**TOWN OF NEWBURGH
PLANNING BOARD
TECHNICAL REVIEW COMMENTS**

PROJECT: MINARD II SUBDIVISION
PROJECT NO.: 21-02
PROJECT LOCATION: SECTION 20, BLOCK 1, LOT 31.1
REVIEW DATE: 30 JULY 2021
MEETING DATE: 5 AUGUST 2021
PROJECT REPRESENTATIVE: TALCOTT ENGINEERING/CHARLES BROWN

Re: Resubmission letter
Town Project No. 2021-02
Minard II Subdivision
97 Leslie Road
SBL: 20-1-31.1
R-2 Zone
Job No. 20179-MIN

DATE: 01/07/2021 SCALE: 1"=20' JOB NUMBER: 20179-MIN SHEET NUMBER: 2 OF 3

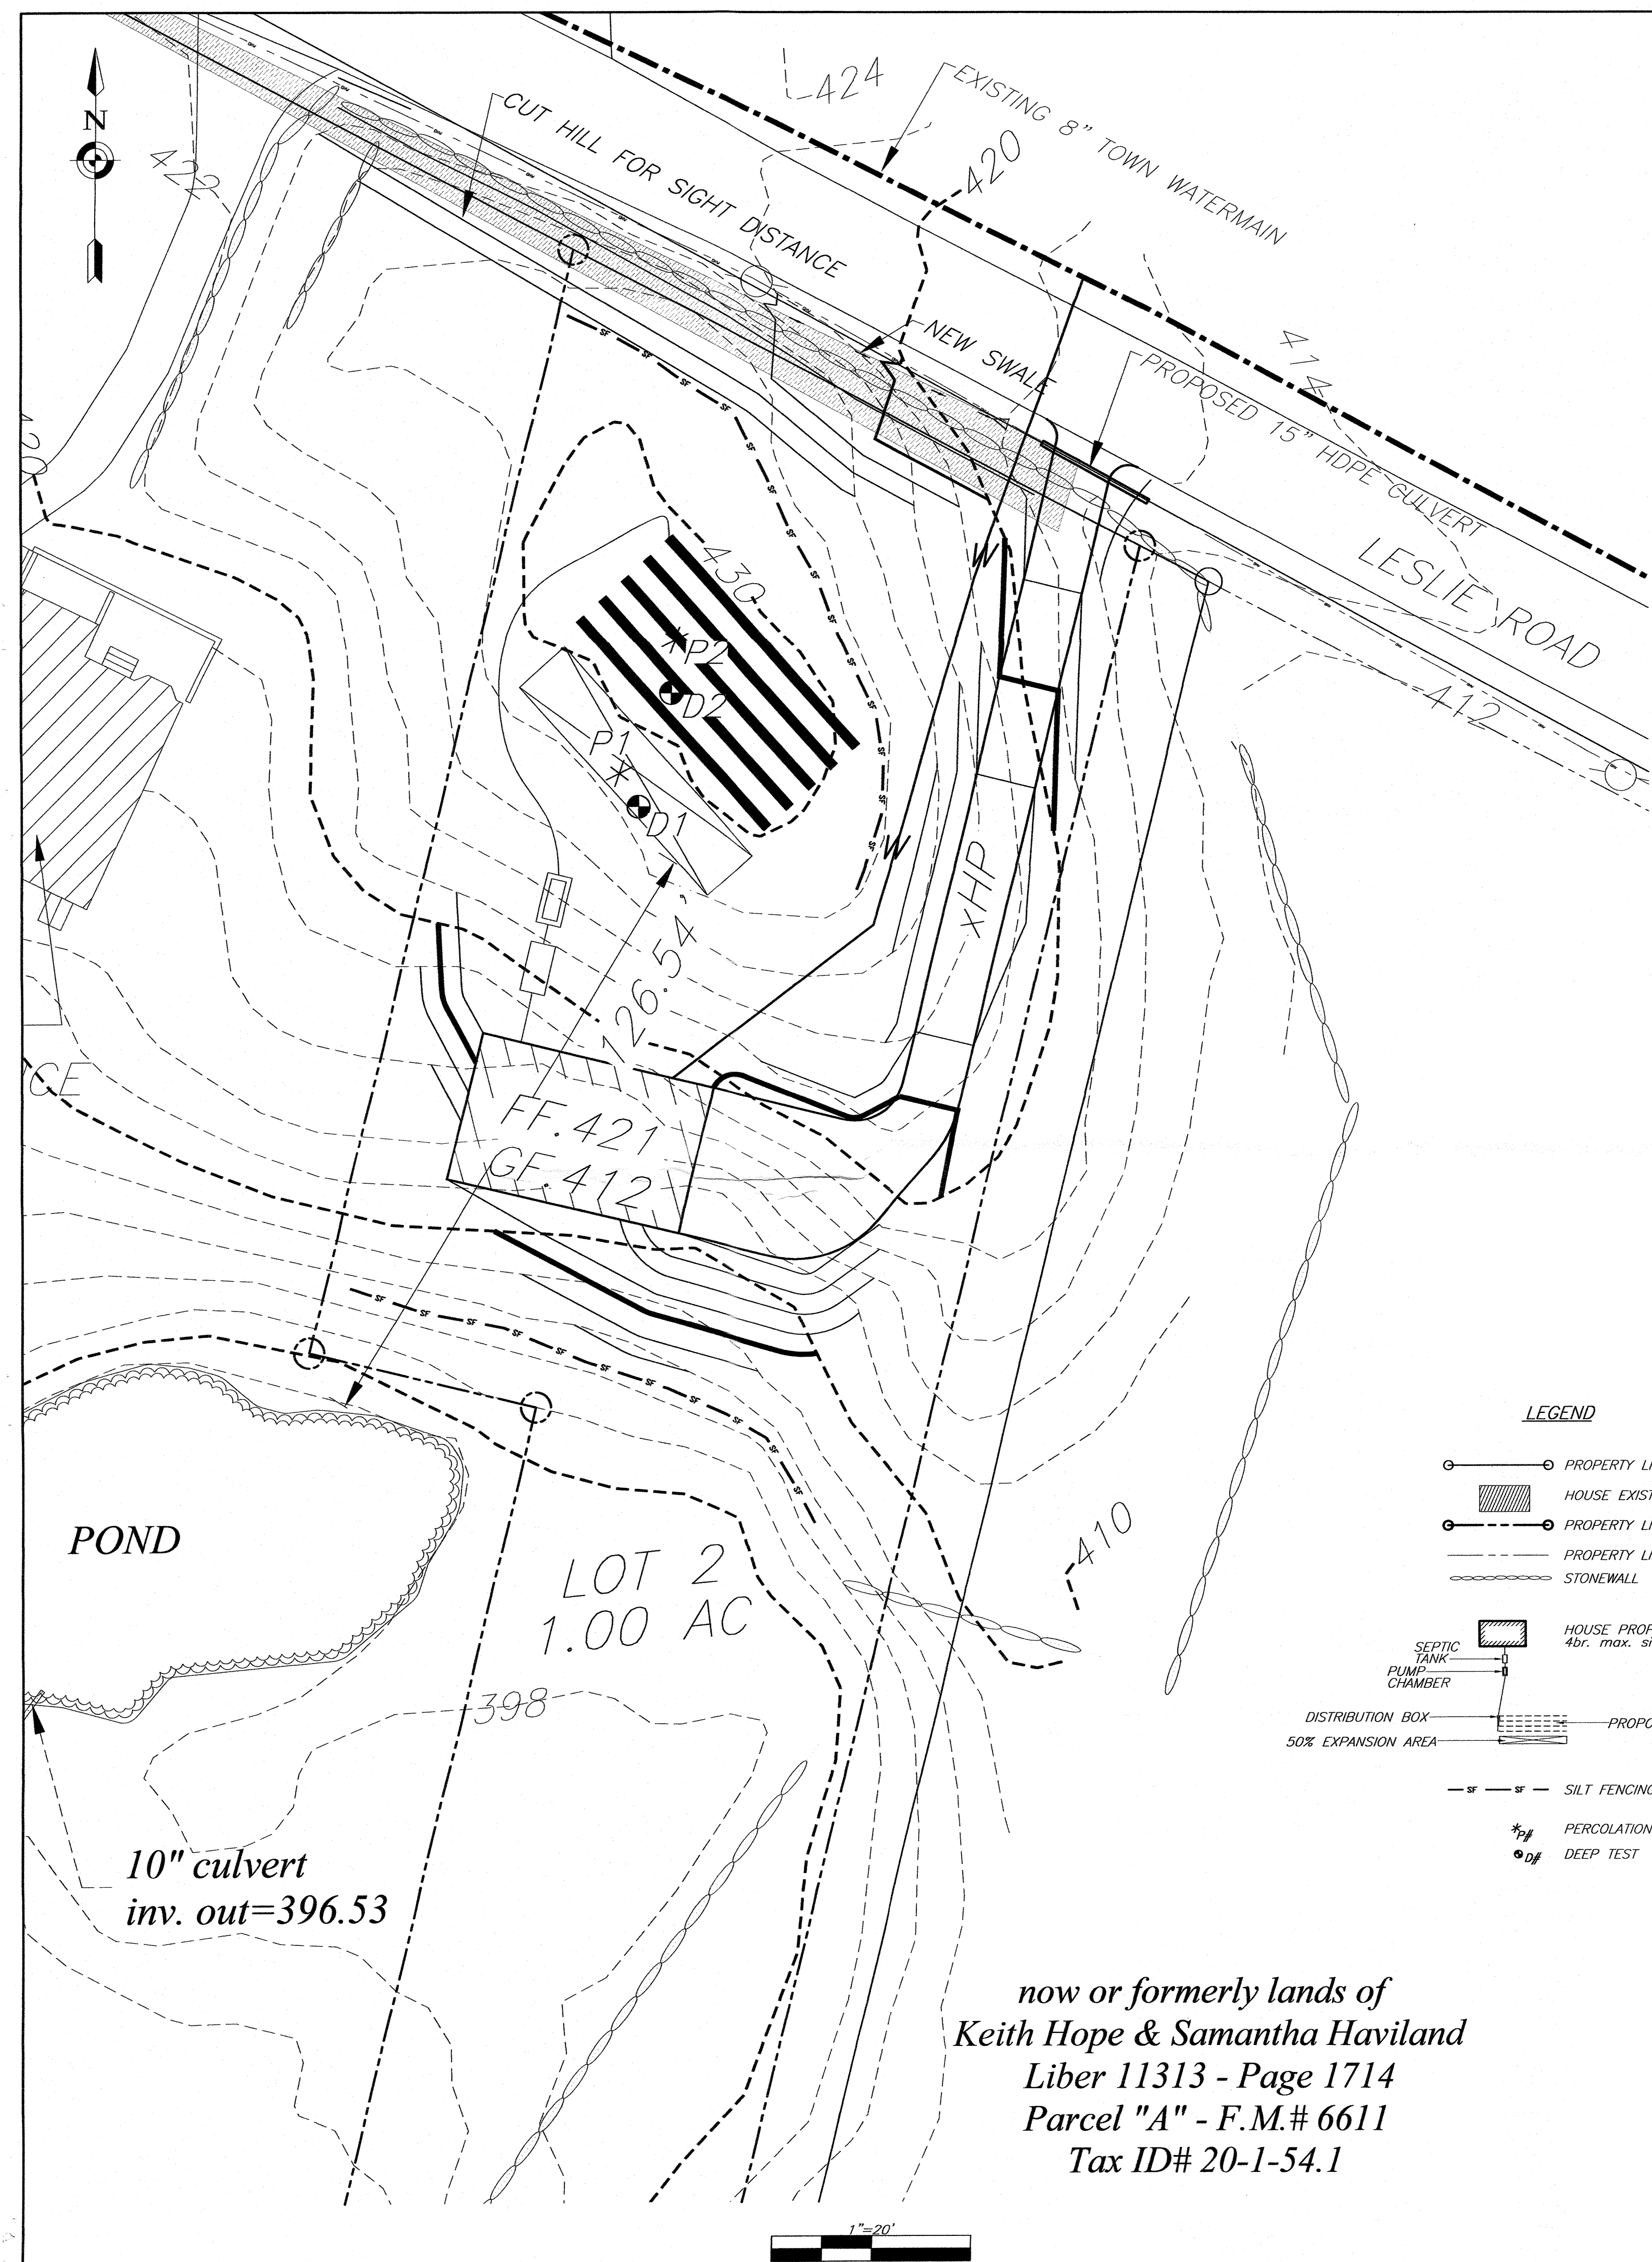
1. As previously noted, this office continues to have concern regarding the 15-foot strip located on the Western portion of the property. The 15-foot strip is identified as a future driveway. Grading may cause issues within the 15-foot strip for a future driveway. The location of the 15-foot strip will cause two (2) driveways to be located within several feet of each other. Based on the current layout it appears that future subdivision of the project is envisioned and may be required to be addressed during SEQR review for the current 2-lot subdivision.

2. The applicant's response identifies that grading for a future driveway is shown. It appears that the grading is for the driveway of proposed Lot #2 and not within the 15-foot strip between Lot #2 and the adjoining parcel.

3. Highway Superintendent's comments regarding the proposed driveway location should be provided.
4. The site distance note has been added to the plans, however, it is unclear by whom and when the site distance clearing will be undertaken. Easements should be provided to allow for maintenance of the site distance clearing in favor of Lot #2 across Lot #1.

- 1) Grading for the future driveway is shown.
- 2) Plans will be delivered to the Highway Superintendent's on Monday.
- 3) Easements have been added to plan.
- 4) Updated water system notes are placed on the plans.
- 5) A drawing has been added with erosion and sediment control plan and details.
